**CITY OF LEAWOOD
GOVERNING BODY
MEETING AGENDA**

Monday, January 6, 2020
Council Chamber
4800 Town Center Drive
Leawood, KS 66211
7:00 P.M.

Staff met with the Ranch Mart applicants on December 9, 2019 to discuss areas of disagreement on the revisions to the Ranch Mart project, following the November 26, 2019 Planning Commission Meeting.

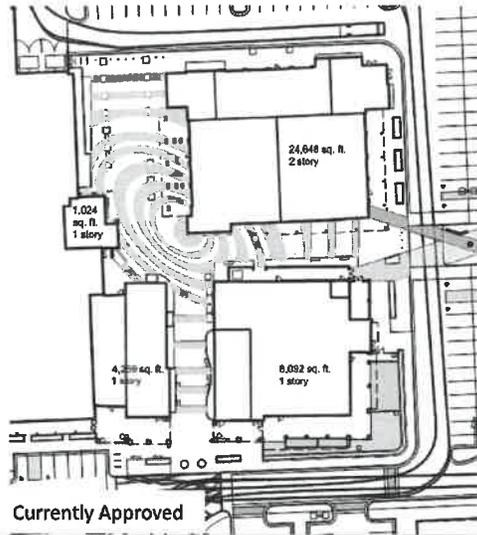
- c. The applicant originally proposed to remove the elliptical pavement pattern in Fox Gray and replace with a saw cut pattern with no color. Following the meeting, the applicant added coral colored bands of scored concrete to the patio.

Discussed with no resulting change

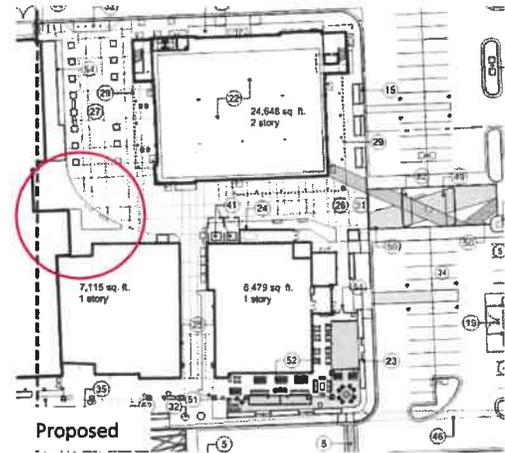
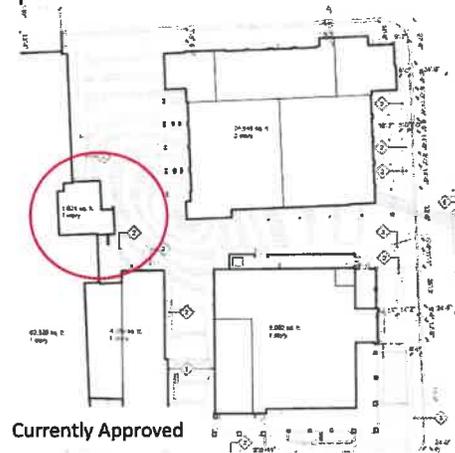
- d. The applicant removed the interior courtyard kiosk, as shown on the previous plan.

Discussed with no resulting change

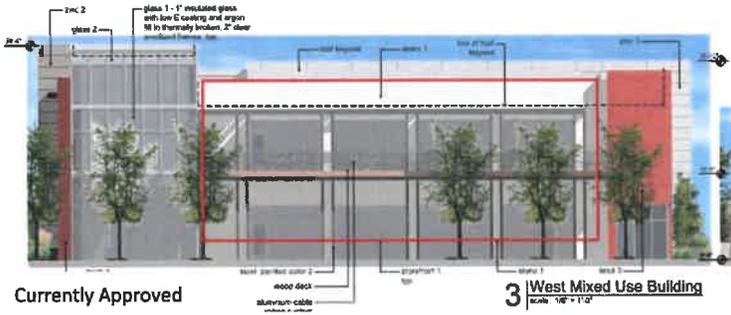
e. The applicant is proposing to reduce the size of perennials and grasses from #1 containers to plugs and increase the spacing between plants from 18" to 24".

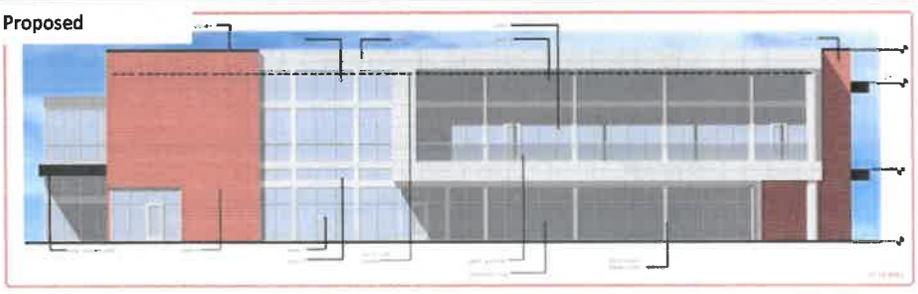
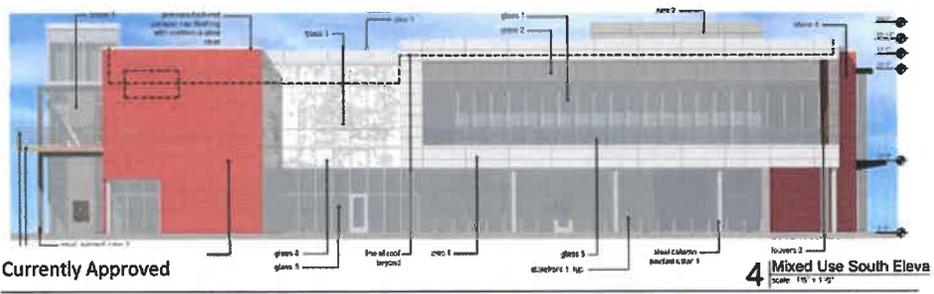
h. The applicant lowered the tower elements of the office/retail building.

Discussed with no resulting change

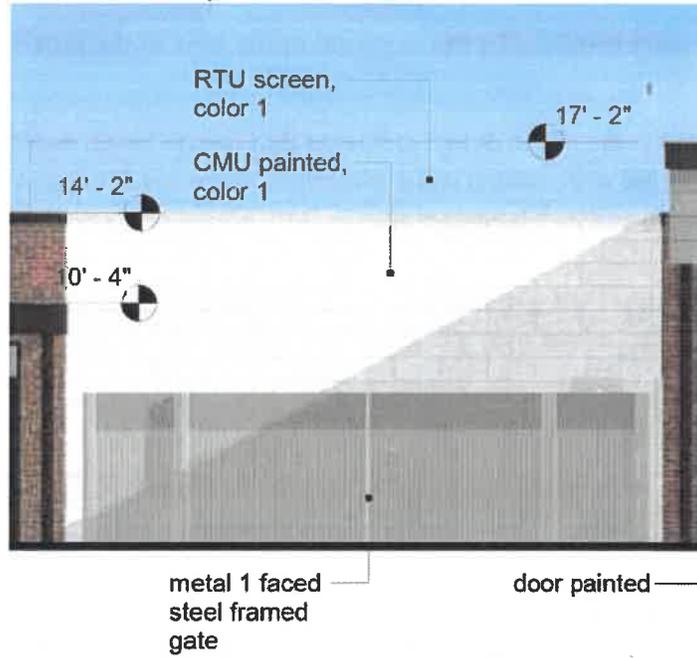
j. Applicant is proposing to keep existing CMU exterior finishes, which is prohibited by the Leawood Development Ordinance.

Discussed with no resulting change

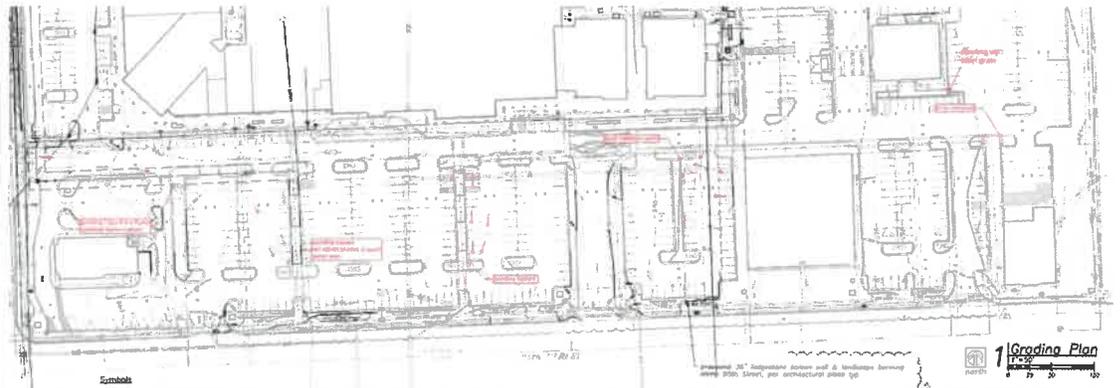
k. The currently approved plan does not show parking lot drainage flumes throughout the site. The applicant is proposing to add multiple drainage flumes to the parking lot.
